SUBJECT: PALO VERDE NUCLEAR GENERATING STATION - REVISED REDACTED  
VERSION OF RESPONSE TO INFORMATION REQUEST DATED  
FEBRUARY 10, 2005

**Redacted Response to Information Request in NRC  
Special Inspection Report 05000528/2004014;  
05000529/2004014; 05000530/2004014**

In NRC Special Inspection Report 05000528/2004014; 05000529/2004014; 05000530/2004014, dated January 5, 2005, the NRC requested additional information regarding the preliminary results of pump testing, associated analyses, and preliminary assessment of the safety significance of the Emergency Core Cooling System (ECCS) voided suction piping condition as submitted to the NRC in letter dated December 27, 2004. The additional information is provided below. Arizona Public Service Company (APS) will submit a comprehensive final report containing a description of the final results of the tests and analyses performed, and our final assessment of the safety significance prior to the Pre-decisional and Regulatory Enforcement Conference scheduled for February 17, 2005.

### Typical Pump Performance Determination

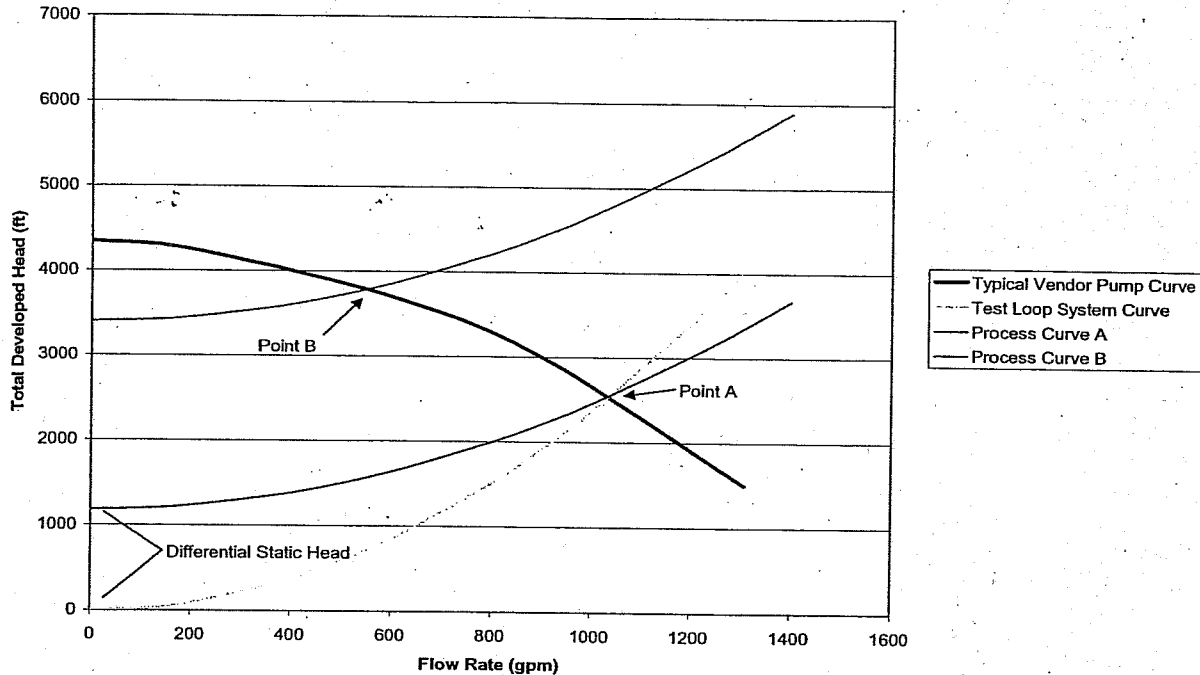
{Provide} a more comprehensive discussion on the scaling factors used to establish the test conditions for the full scale pump tests (e.g., system resistance).

As illustrated in the above figure, the pump's performance (developed discharge head and flowrate) is determined by varying the system resistance, usually by setting the position of a throttle valve on the discharge of the pump. The result is a test loop system curve like the yellow line in the above figure. For any centrifugal pump, its performance at a particular system resistance will be set at the intersection of the system curve and the pump curve. For this example, point A represents the pump's performance in a test loop at a representative point corresponding to a certain position of the discharge control valve. Varying of the position of the throttle valve by opening or closing the valve will decrease or increase the concavity of the parabolic shape of the example test loop curve, maintaining the same zero intercept. There is little or no static head component to the system curve since in most test loops the suction and discharge sources are the same. When placed in a process system, however, the pump's performance will be determined by the intersection of the process system curve and the pump curve. The process system curve may involve other elements in addition to system resistance. Two examples are illustrated in the above figure. The blue line (Process Curve A) would occur by a case in which a combination of differential static head and system resistance combine to produce an intersection with the pump curve at the same point as in the test loop. The system curve can be analytically developed using Bernoulli's extended energy equation. For the example illustrated by the blue system curve, the pump will produce the same developed head and flow rate as it did in the test loop, even though the system resistance in the process system is different than in the test loop.]<sup>1</sup>

[The green line (Process Curve B) illustrates what happens when the same pump operates within a system with greater static head (e.g. due to increased system back pressure). Again, the intersection of the system curve with the pump curve (Point B) determines the pump performance. In this example, the pump would develop greater discharge head but less flow rate. The example illustrates how a pump's performance can be determined for process systems that have no relationship in terms of system resistance to that with which the pump was originally tested under. For the system being considered, the required variation in pump performance is the sole result of variations in static head with a fixed system resistance.

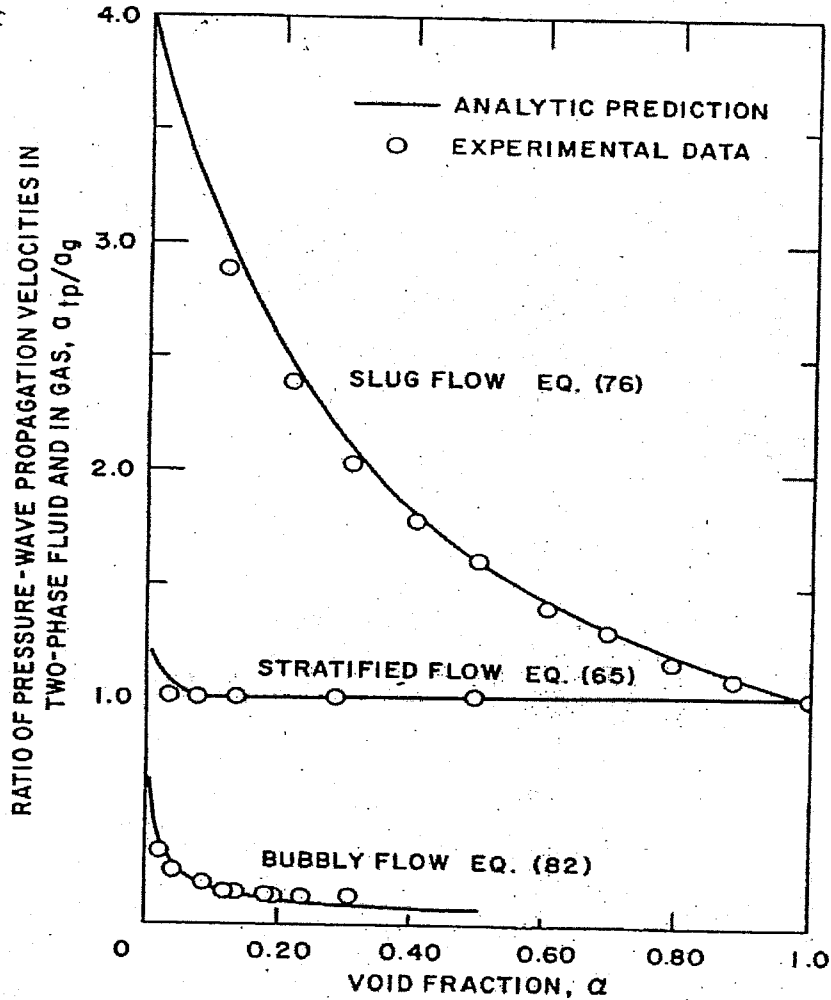
Address any potential negative impacts stemming from water hammers.

The ECCS voided piping condition did not present any negative impacts stemming from waterhammer. Numerous analyses and experiments have been performed to evaluate the influence of air in a system during a strong hydraulic transient such as a pump start (Chaiko and Brinckman, 2002 (reference 1), Lee and Martin, 1999 (reference 2), and Martin, 1976 (reference 3)). As stated by Martin:

*The effect of the presence of entrapped air on transient pressures of a liquid pipeline can either be beneficial or detrimental, depending on the amount of air, the two-phase flow regime of the mixture (whether homogeneous or slug), and the nature and cause of the transient.*

Of particular importance are those situations which could be detrimental to the piping system. Generally these are conditions in which a significant coherent gas volume has formed on the discharge side of the pump. Significant means a volume that is comparable to or larger than the integrated volumetric flow discharged from the pump during the time that it comes up to speed. Given these conditions the pump can accelerate to essentially run out flow conditions with the only resistance being the frictional forces generated by the moving water column between the pump discharge and the air pocket. Subsequent to this, the moving water column will begin to compress the air volume and the gas pressure will increase dramatically as volume is reduced.

For example, under these conditions the gas bubble pressure more than doubles when the gas volume is reduced by one half and similarly more than doubles again when it is reduced again by one half, etc. Hence, with a low pressure gas volume on the discharge side of the pump, the compression of the gas bubble will eventually absorb the kinetic energy of the water column. For this to occur, the gas volume pressure can increase to values much greater than the maximum pump discharge pressure.

As illustrated, for stratified flow the pressure wave propagation velocity was reduced by a factor of four while bubbly mixtures experienced a reduction of as much as two-orders of magnitude. Consequently, a uniformly distributed gas volume will slow the response to transients (i.e., stabilize the flow). This is consistent with the example calculations provided by Martin (1976) – Reference 3.]<sup>1</sup>

..]¹ Thus, it is concluded there are no negative impacts due to water hammer stemming from the presence of air in this section of the ECCS piping.
